SERVICE BULLETIN

EL20-033

2017-2019 ARMADA; ENGINE DOES NOT CRANK

APPLIED VEHICLES: 2017-2019 Armada (Y62)

Figure 3

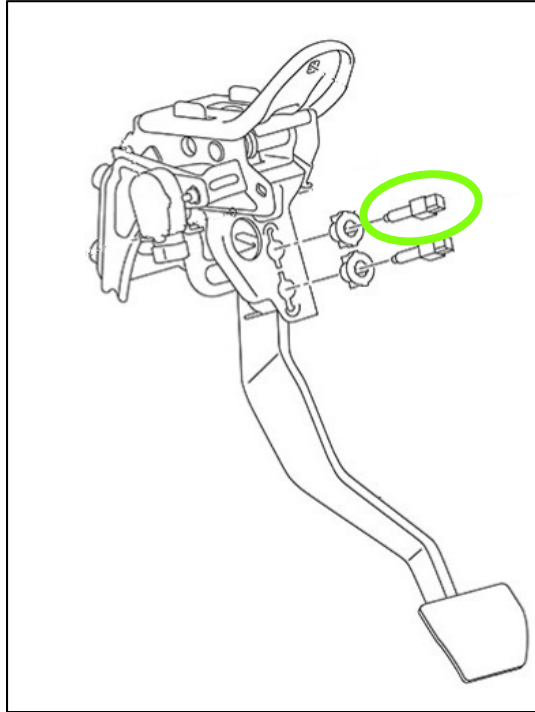
The color of the stop lamp switch is solid black, as shown in Figure 1.

NOTE: The updated stop lamp switch will have a black body with a green connector end.

Replace the stop lamp switch.
